Kōrero mai | Let's talk

MacFarlane Park - tree planting plan submissions

SHEET 4672500-AL-M-033

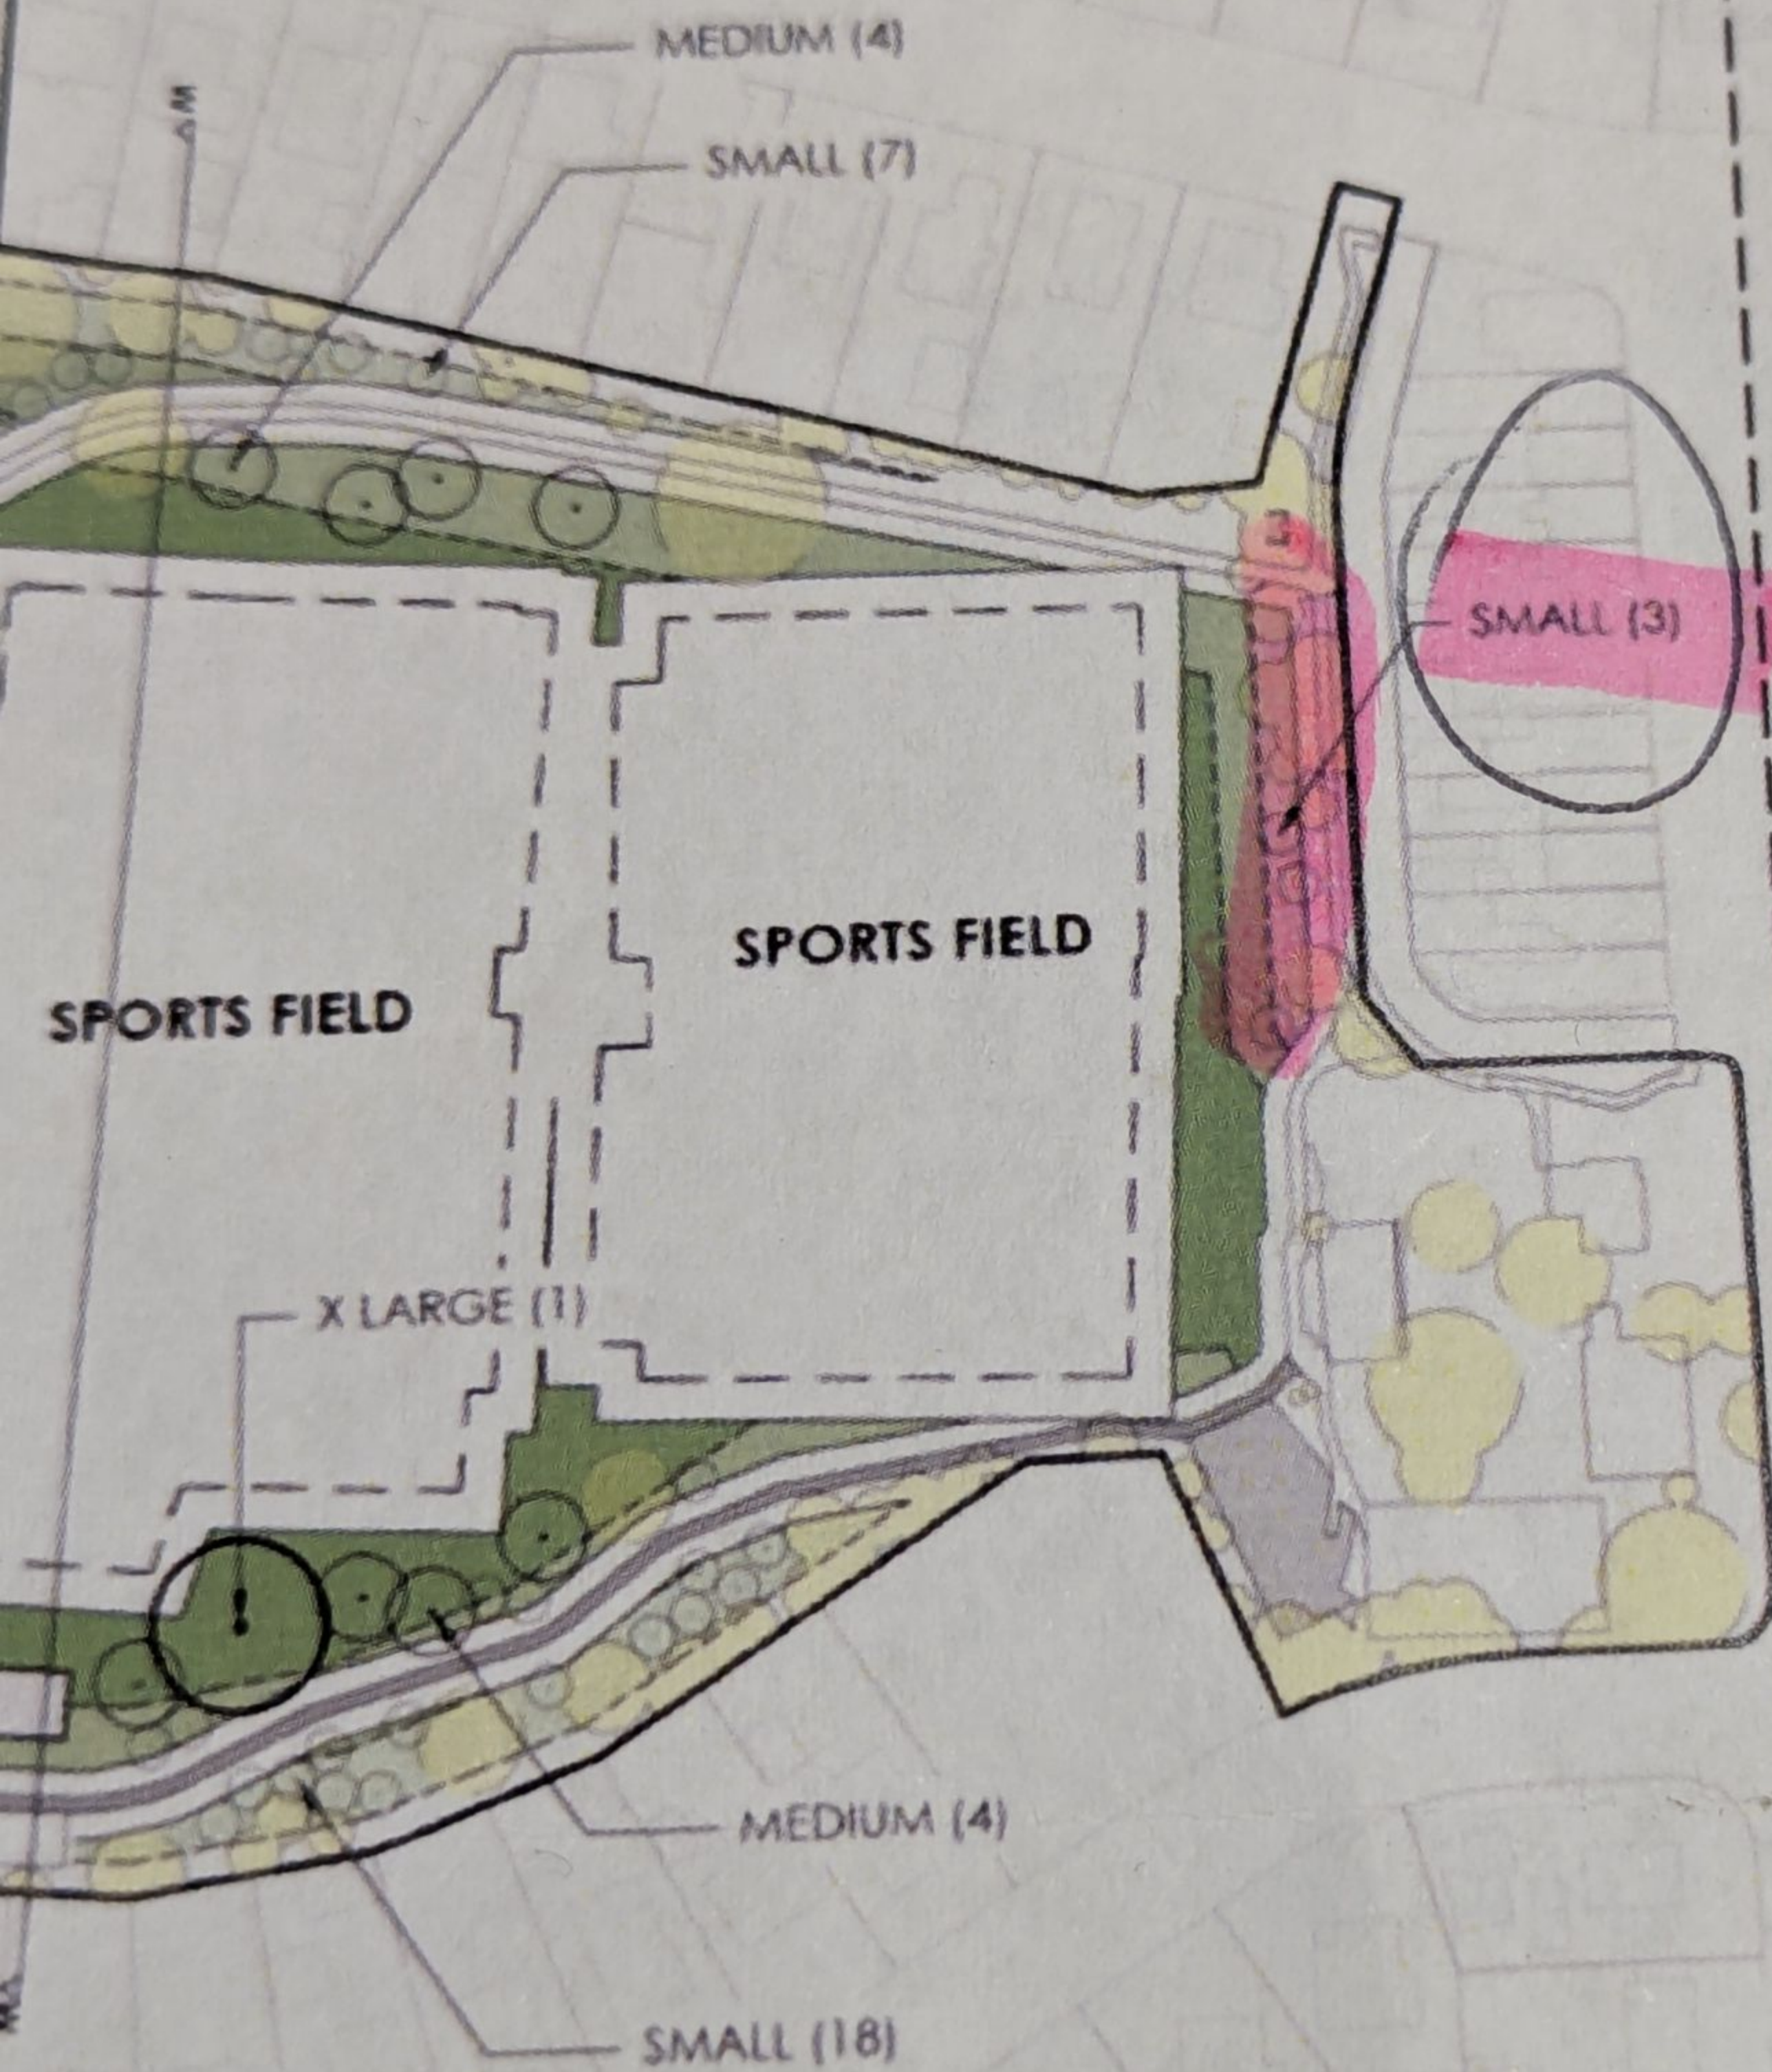
If possible, in the area highlighted (where it says 3 small trees), would it be ok to only plant trees that have a max height of 4 meters? In winter, any trees above this height block sun into our house which makes it really cold and hard to keep mould free.

Grasses perhaps? or small natives? We love lancewoods, native coprosmas, Dwarf Kōwhai, Weeping Māpou, Canterbury Plains Tree Daisy, Muehlenbeckia?

Could you please consider removing one existing tree that has started rotting? many branches have rot, and in the past it has dropped a big branch right onto the pavement under it (quite a hazard). It's also really tall and blocks our light. Some community members have taken to DIY pruning it, which is a bit risky as they are not arborists.

If possible, it would be amazing if the new trees don't have seeds or leaves that will fly everywhere (the ash trees that are currently there have little seeds that go absolutely everywhere, blowing inside through the louvers, and covering the inside of our house (lol).

It would be ideal if the new trees were natives for this reason.
